Review of Plans: **Amazon Site Plan Amendment, 200 & 400 Oritani Drive, Blauvelt, New York, 10913**

Subject: **Amazon Site Plan Amendment**
200 & 400 Oritani Drive, Blauvelt
65.18/1/1 & 22 and 70.06/1/1.12; LO zoning district

Delivery Station Expansion drawing package as prepared by CESO, last revised 10-17-2023 and narrative and binder as prepared by Cuddy + Feder, dated January 18, 2024.

Subject: **Amazon Site Plan Amendment**
Prepreliminary/Preliminary/Final Site Plan
Amendment and SEQRA Review
200 & 400 Oritani Drive, Blauvelt
65.18/1/1 & 22 and 70.06/1/1.12; LO zoning district

Existing Sign To Be Removed and Replaced

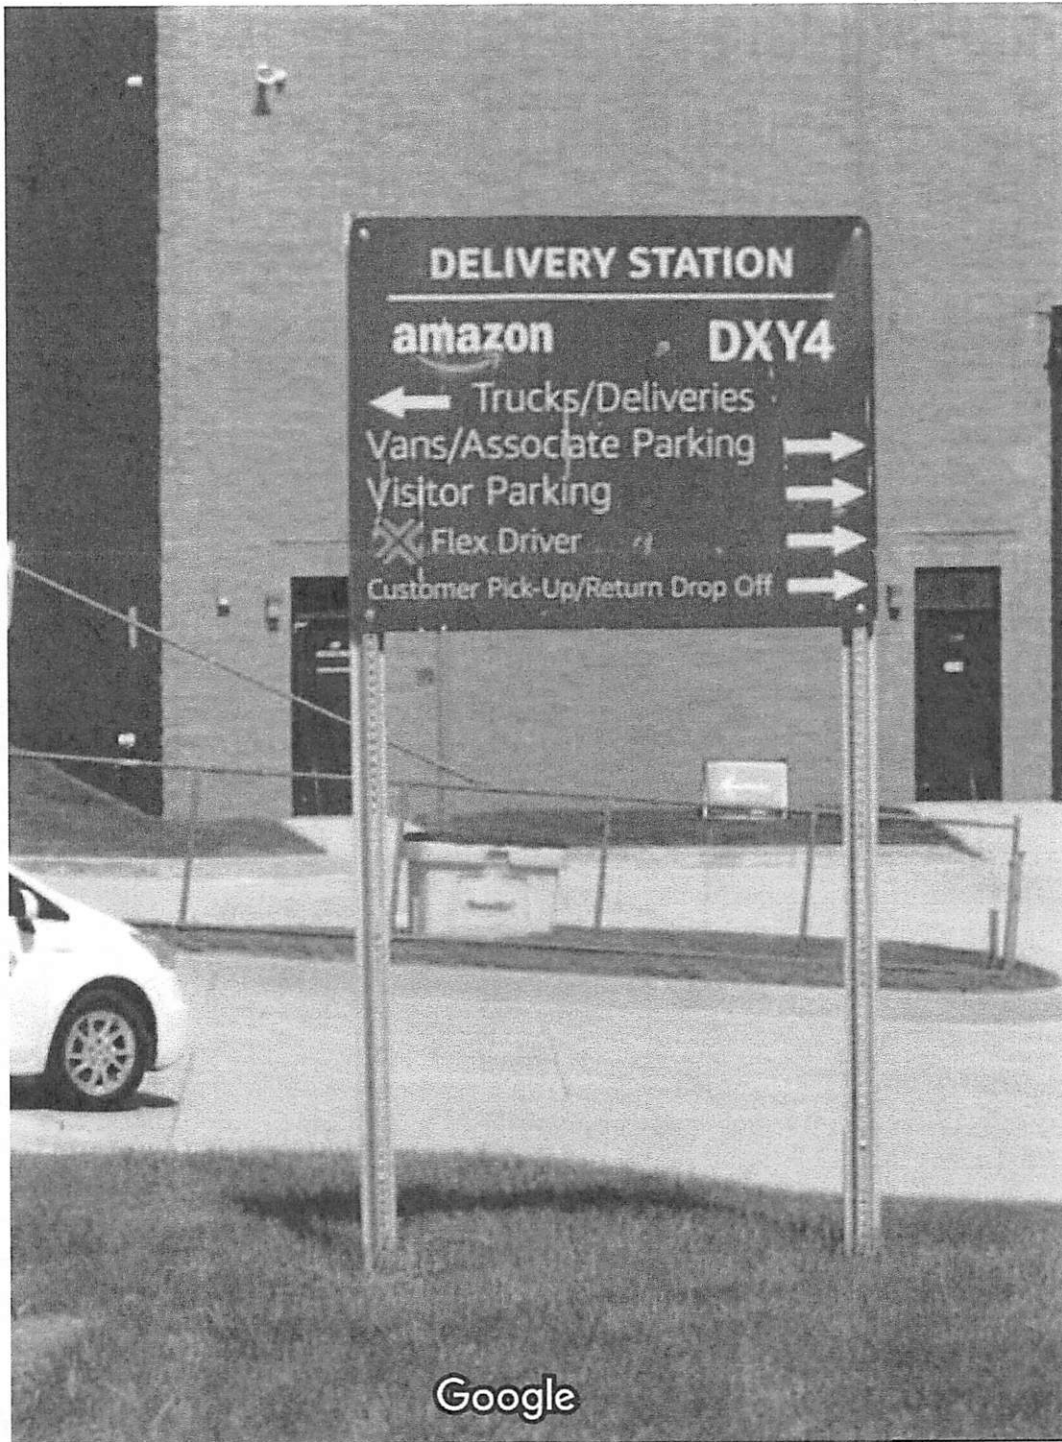
There will be no undesirable change to the character of the community or detriment to nearby properties by the proposed signage. Specifically, the Premises currently has similar signage, including existing signage comparable in size and design as the proposed AS-16 sign. The existing AS-16 sign is proposed to be removed (along with other signage) and replaced with new signage shown on the Sign Package. The existing AS-16 sign that is being replaced is shown in **Exhibit I**.

STRIPING AND SITE PLAN - PHASE 0
 AS1.11

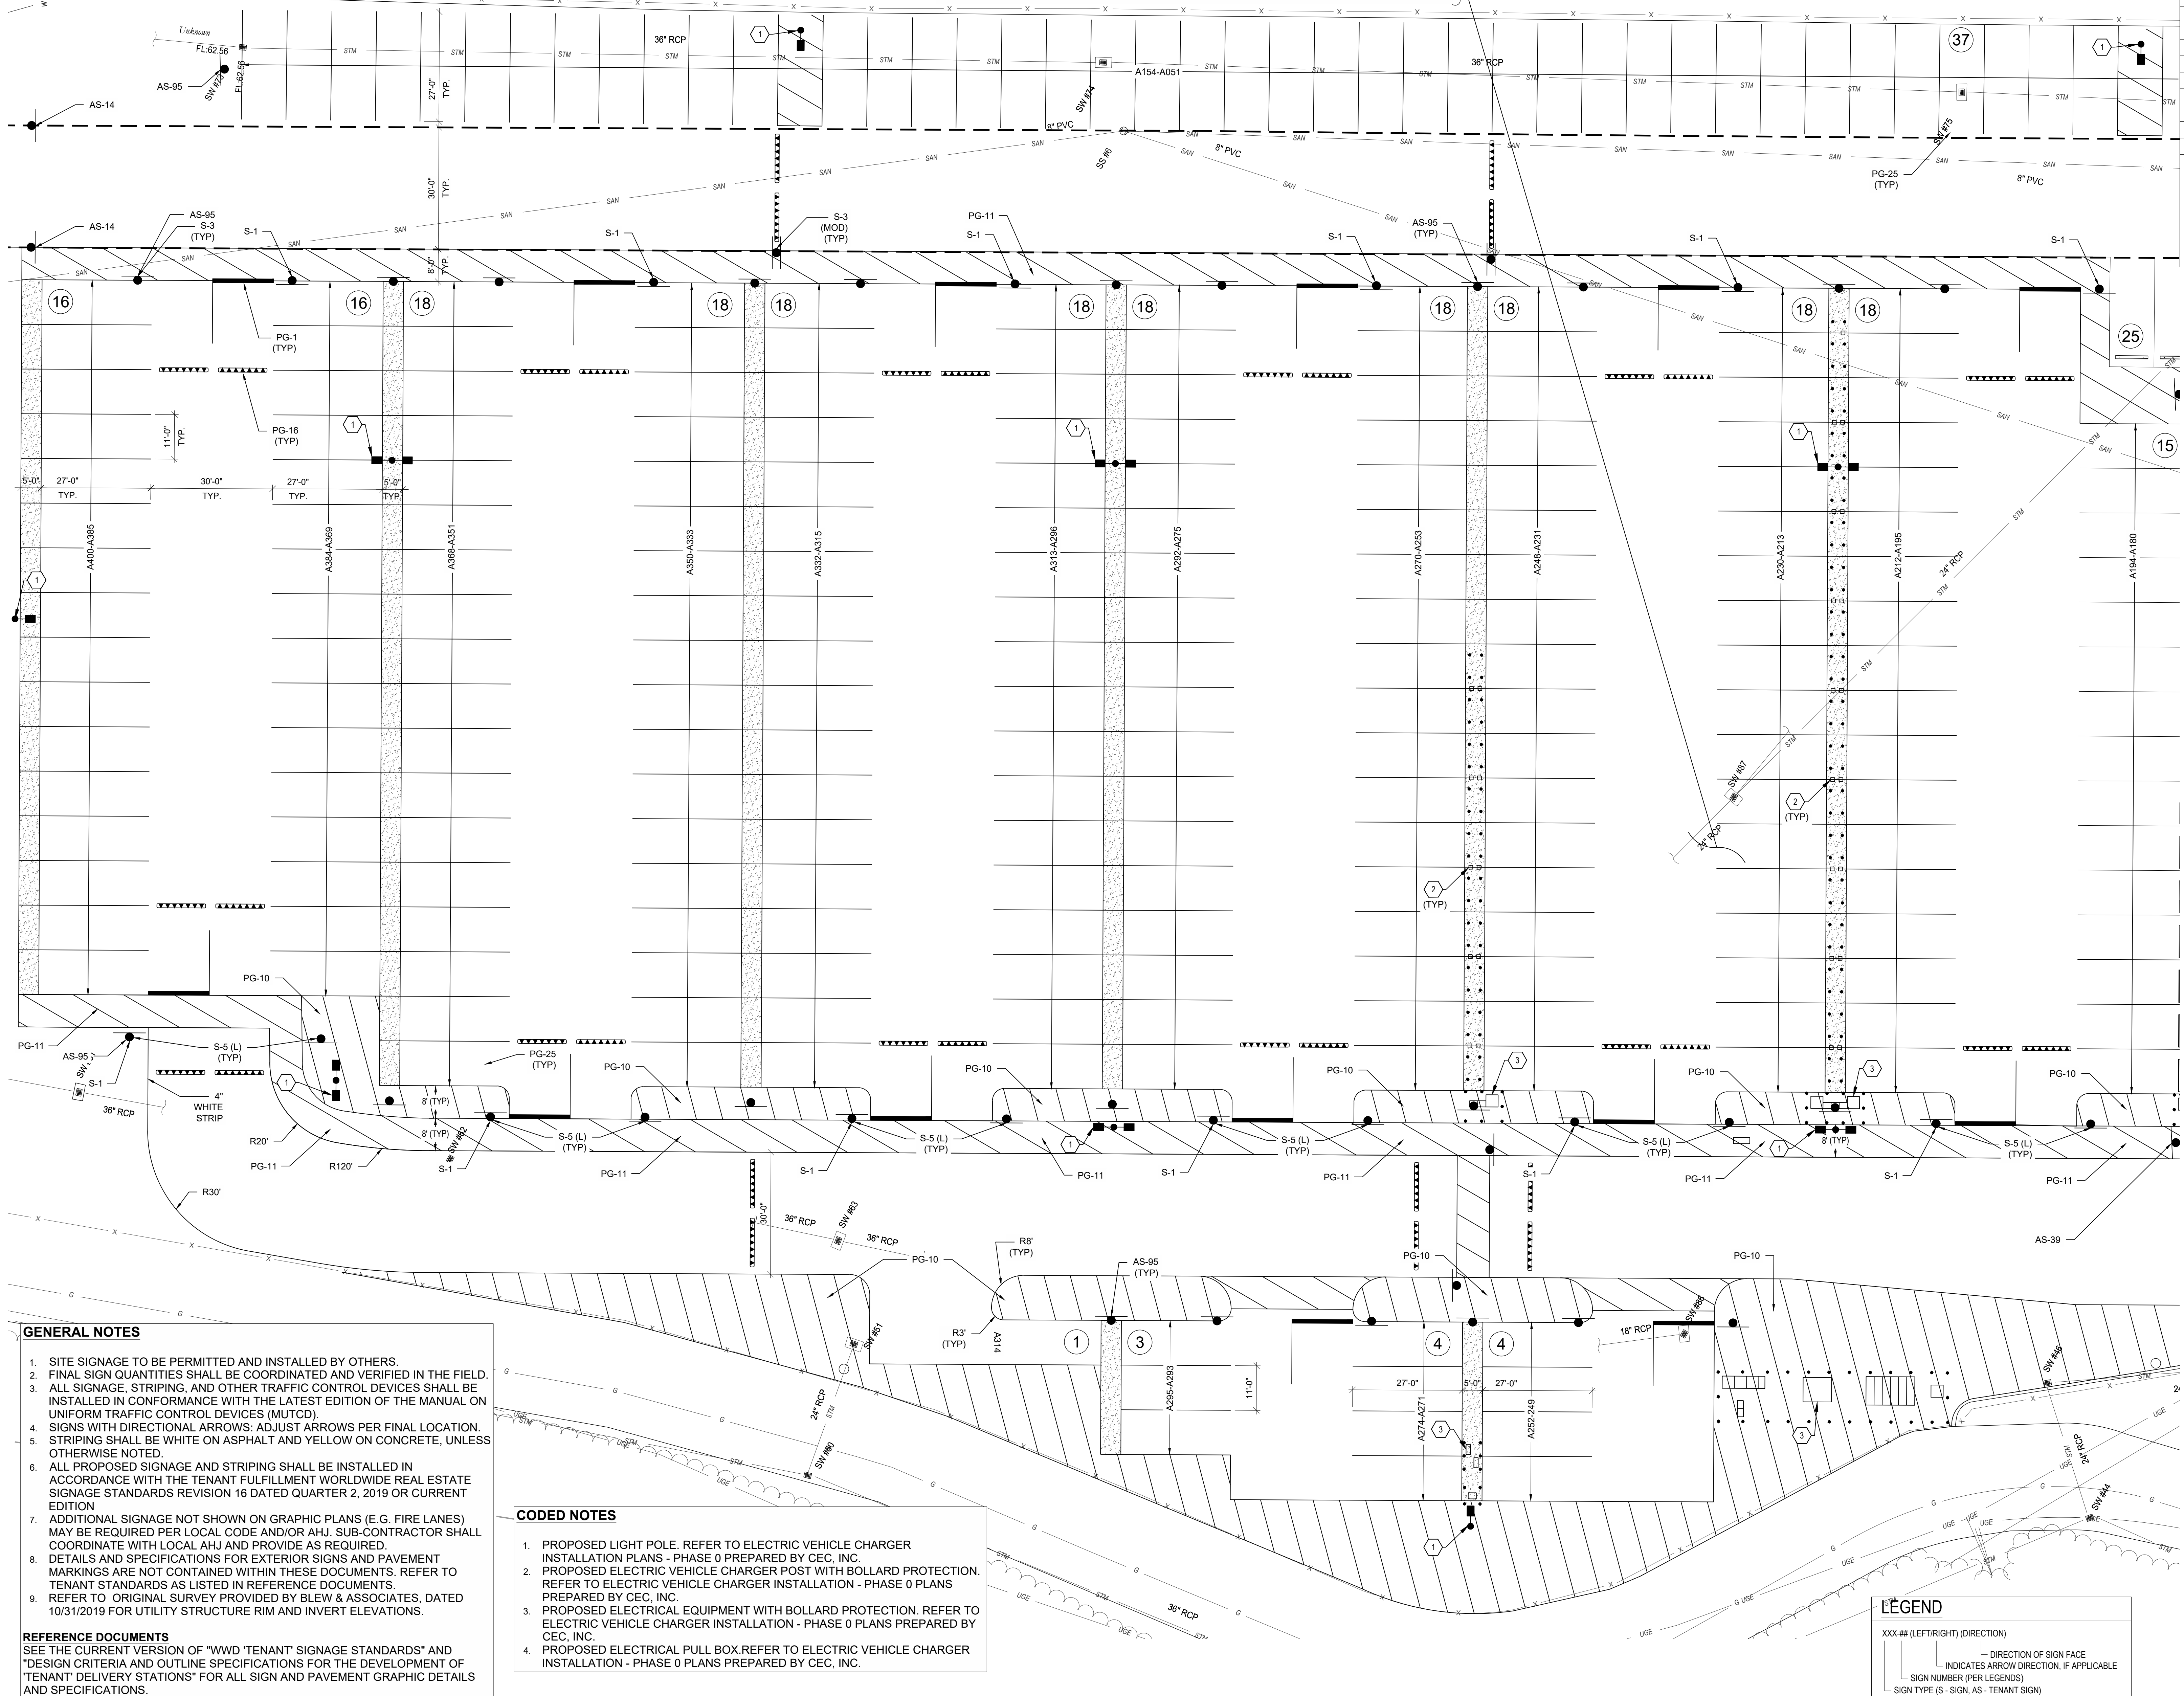
- 3) On Sheet AS1.11, there is a very long legend list of signage, however it appears that only 8 signage types are proposed. Applicant must clarify. Signage that is not proposed should be eliminated from the legends.

AS-16 VAN WAYFINDING PAGE 73

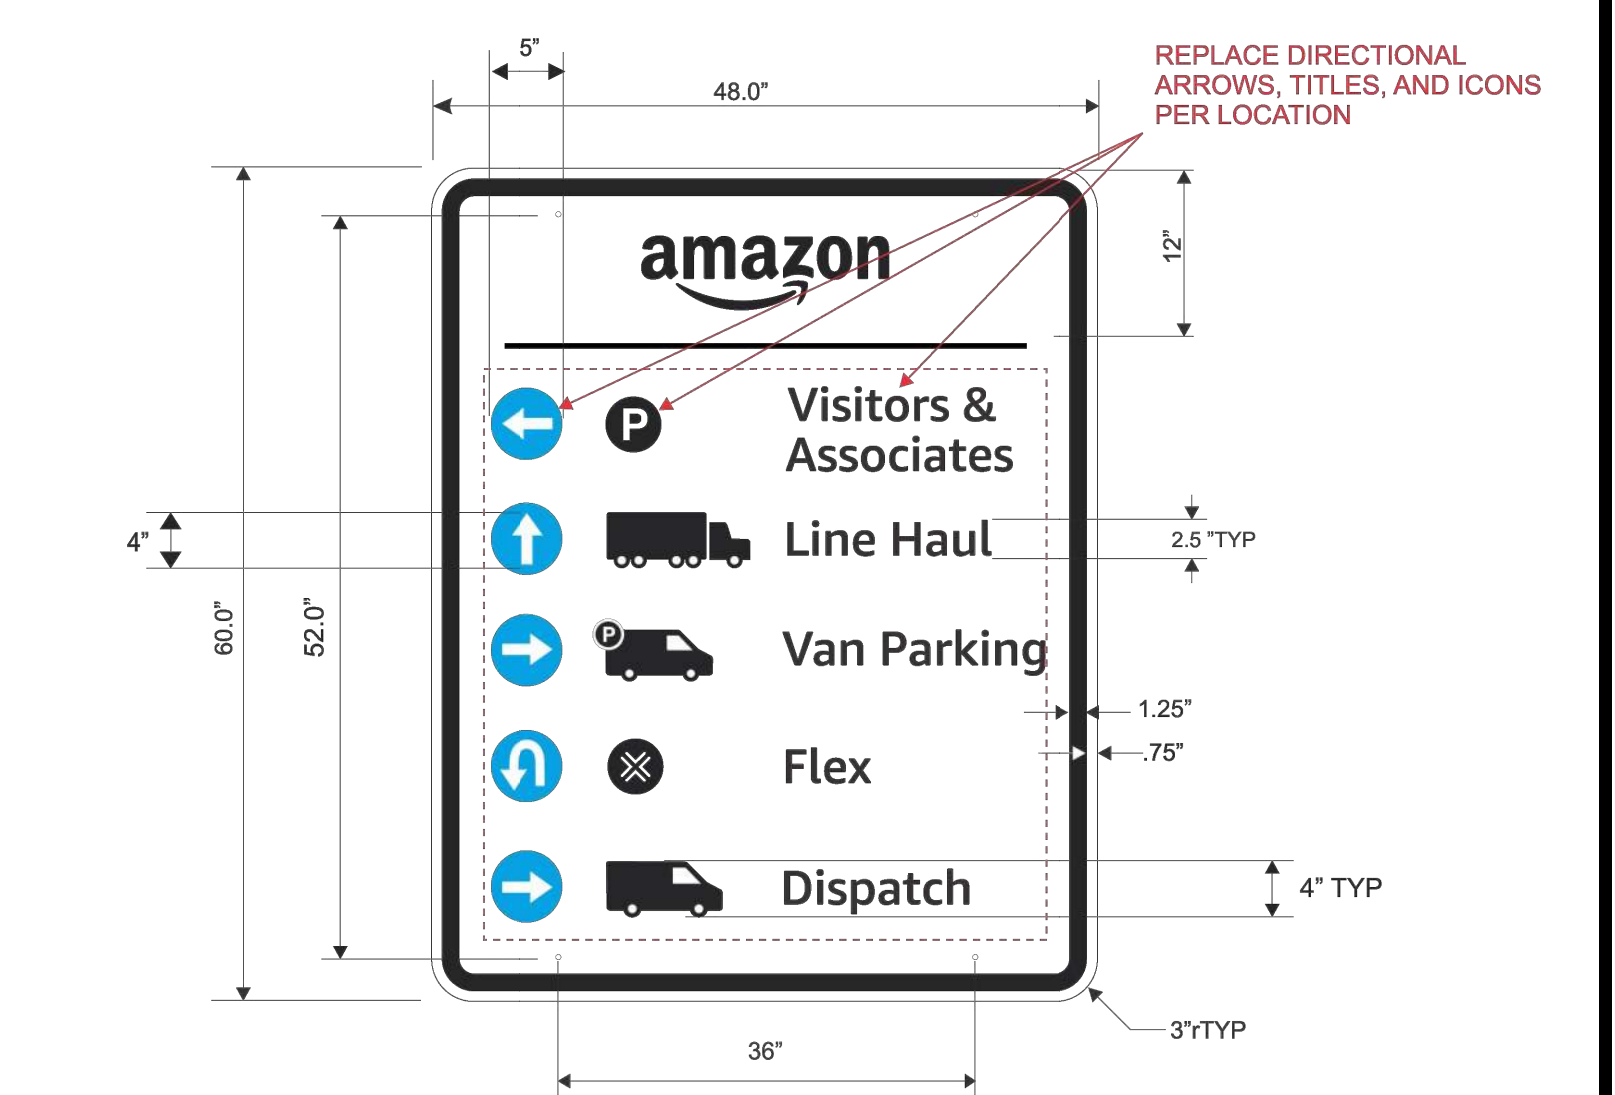
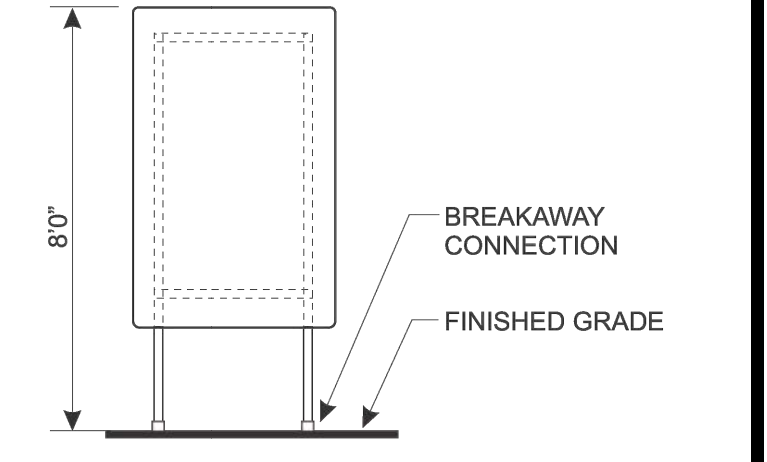
Chapter 43, Section 3.11, LO district, Column 5, #11, (Signage: illuminated signs shall not exceed 30 square feet (1 side) or 60 square feet (2 sides) permitted, 20 square feet over proposed) for the AS-16 sign which contains the Amazon logo. The premises are located at 200 & 400 Oritani Drive, Blauvelt, New York and identified on the Orangetown Tax Map as Section 65.18, Block 1, Lot 1 & 22 and Section 70.06, Block 1, Lot 1.12 in the LO zoning districts.

- 1) A pylon sign of 30 square feet each side, is proposed and in compliance with Table 3.11, LO District, Column 5, no.11.
- 2) Per Chapter 43, Table 3.11, LO District, Column 5, No. 11, One illuminated business sign equal or less than 30 square feet (1 side) or 60 square feet (2 sides) is permitted. The AS-16 sign, which contains the AMAZON logo, measuring 4 feet x 5 feet results in an additional 20 square feet of signage area in addition to the pylon sign referenced above. Variance required.

Following the receipt of the OBZPAE Memo, the Applicant requested and confirmed clarification from the Director of the OBZPAE that the variance was only needed for the proposed AS-16 sign. The Email Correspondence with the OBZPAE Director is included as **Exhibit H**. The Applicant encloses its Sign Package prepared by CESO Architects, Inc. dated March 28, 2024 ("Sign Package") which provides details of the proposed signage, including the AS-16 sign, to be removed and installed and the location of the signage. The Applicant provides an excerpt of the AS-16 sign detail here.

AS-39 PARKING LOT DESIGNATION PAGE 100

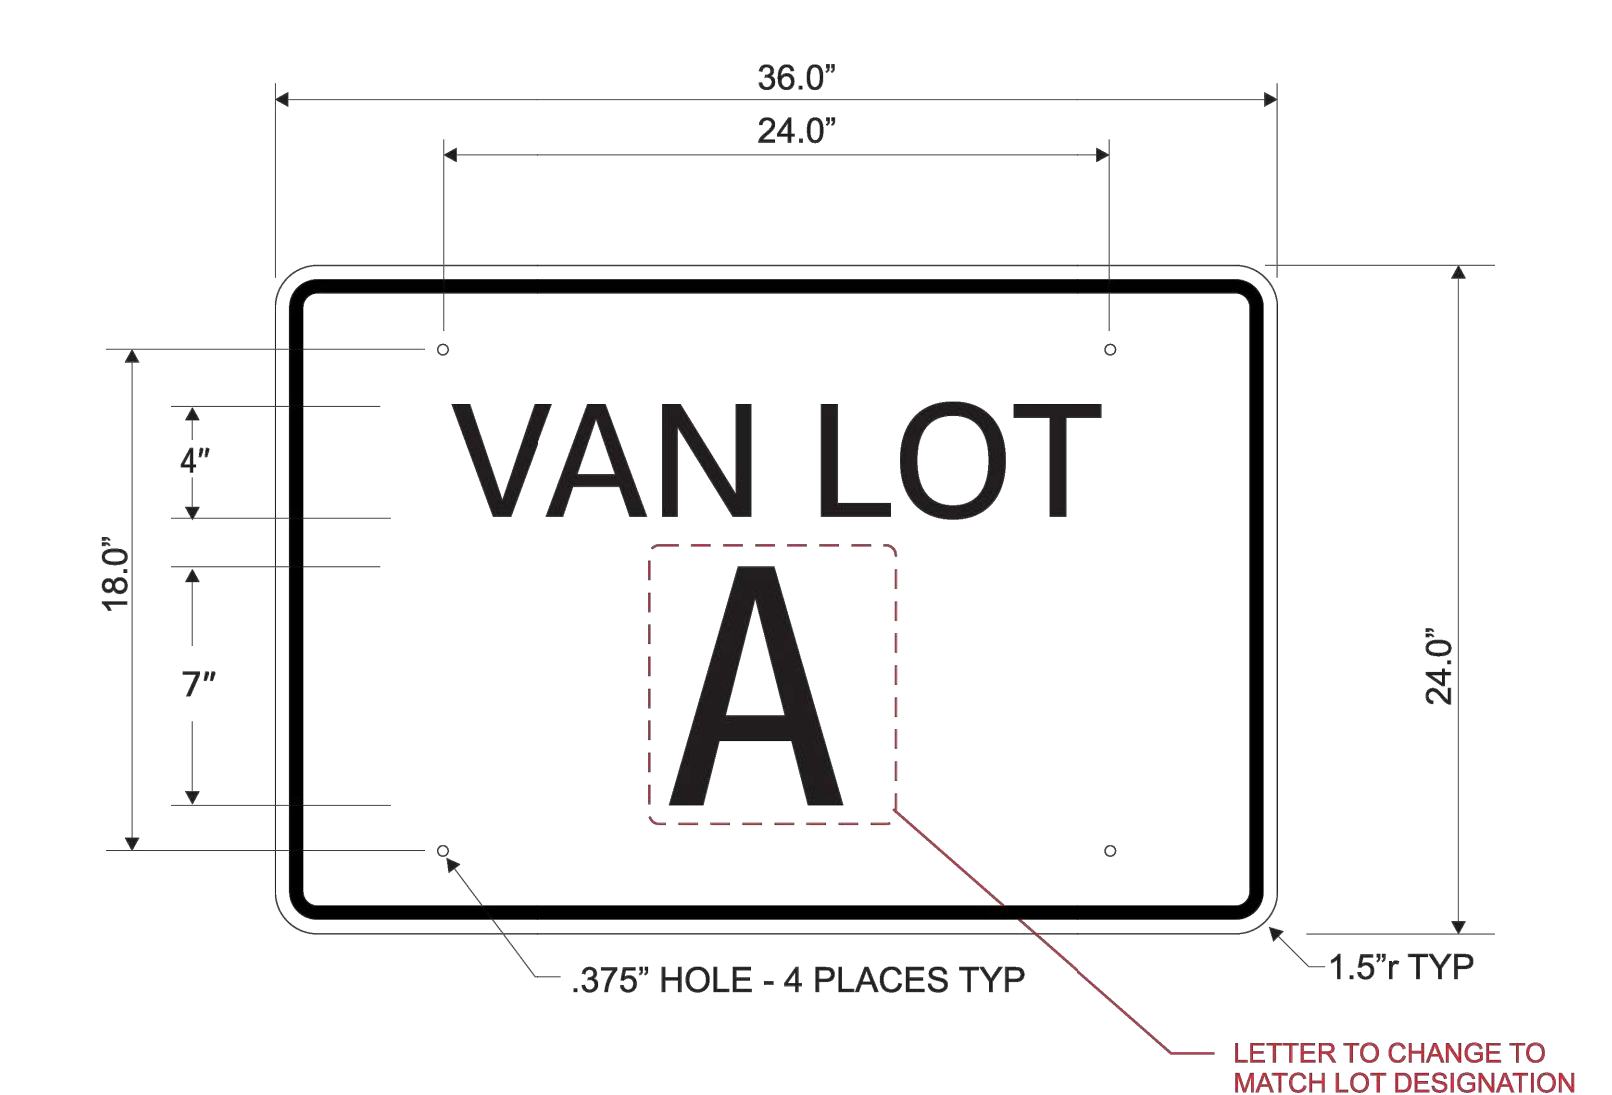
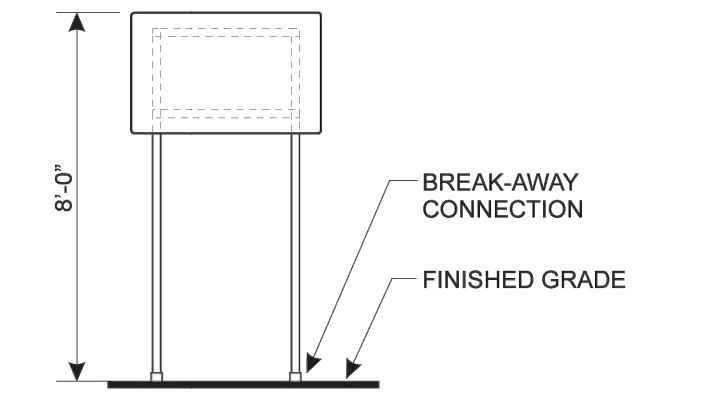
- 4) A pylon sign of 30 square feet is proposed and in compliance with Table 3.11, LO District, Column 5, no.11.
- 5) There are also (2) AS-39 Parking lot designation signs and (21) S-95 Stall wayfinding signs that measure 18"x36", which are 8'-0" tall overall proposed. These proposed signs are quite large and result in 103.5 (4.5 square feet x 23) square feet for a total of 133.5 of proposed signage. Variance required.
